# Initial ILT setting and maximum Tx swing

Comments #218, #263

Adee Ran, Cisco

# Waveforms: two full training frames

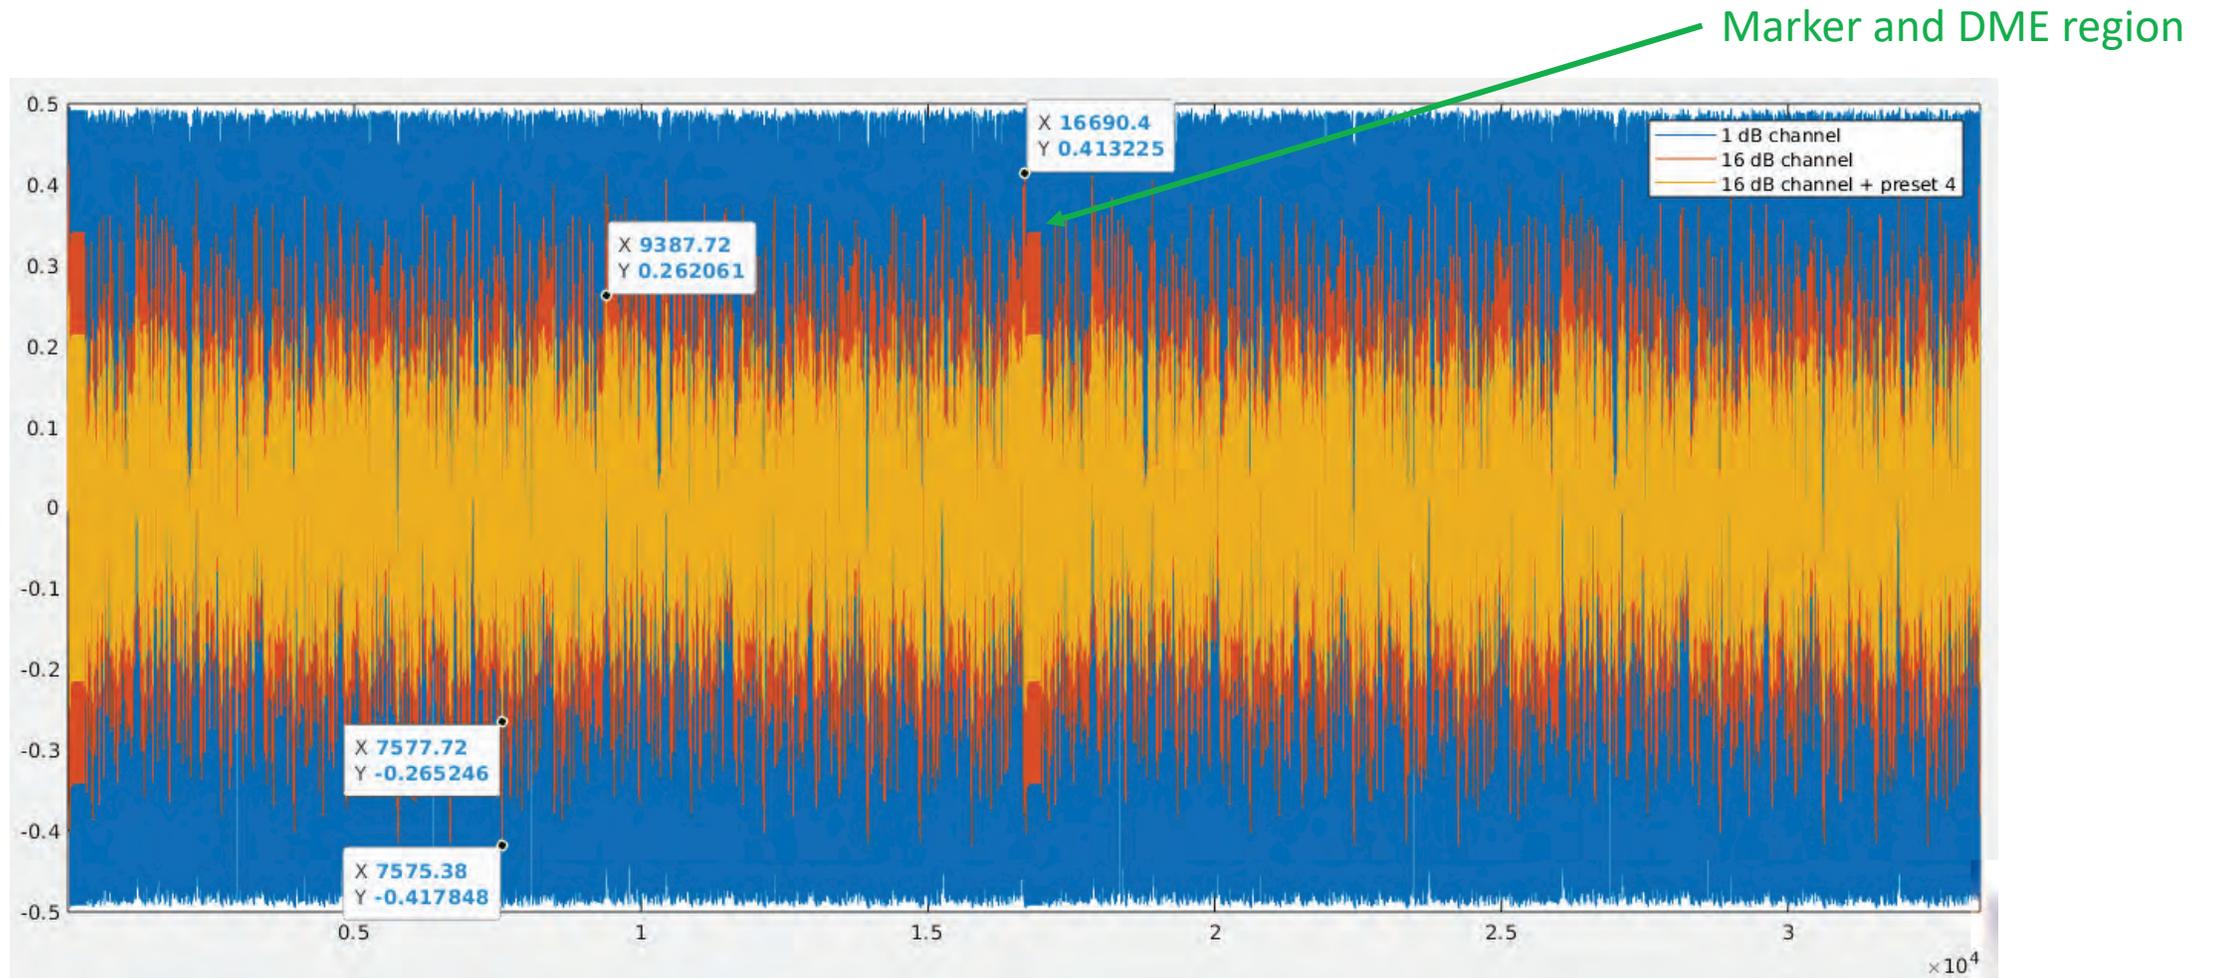
The signal is attenuated by the channel and by the Tx equalizer – the Tx output swing is never seen by the receiver

# Zooming on the training frame marker + DME

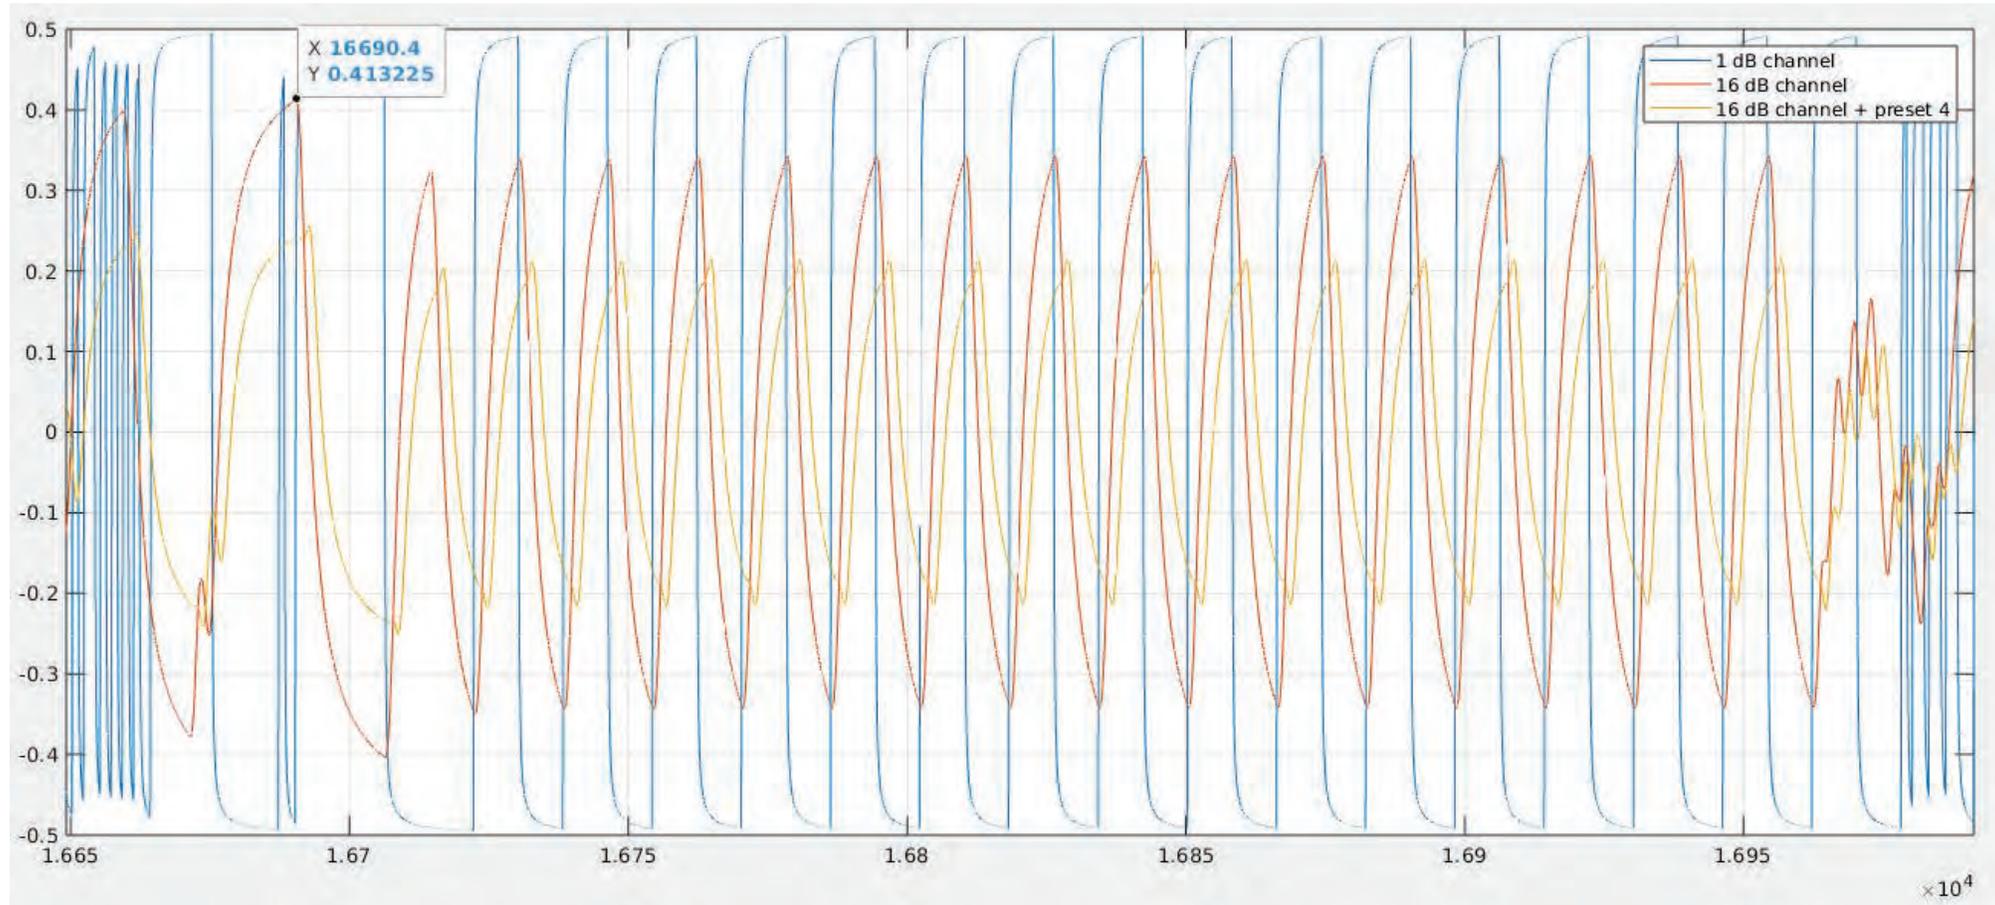
- The 16 dB channel reduces the swing of the training signal from 1 Vpp (Tx) to **0.83 Vpp** (Rx)
  - If preset 6 is used for initialize (change A), it would become **0.62 Vpp** at the Rx input
  - If preset 6 is used for initialize *and* maximum Tx swing is increased to 1.2 Vpp (change C), it would become **0.747 Vpp** at the Rx input – still lower than the current 0.83 V
- Applying preset 4 in the Tx reduces the Rx input swing to **0.53 Vpp**
  - If maximum Tx swing is increased to 1.2 Vpp (change C), it would become **0.636 Vpp** at the Rx input
  - With preset 4, the maximum possible Rx input swing in data mode is **0.72 V** (extremely rare long runs)
- **The input swings listed above should not be a problem for current Rx designs**
  - Experience from 100G SerDes confirms that.
- Practical CR channels have loss much higher than 16 dB – so the values above are conservative.
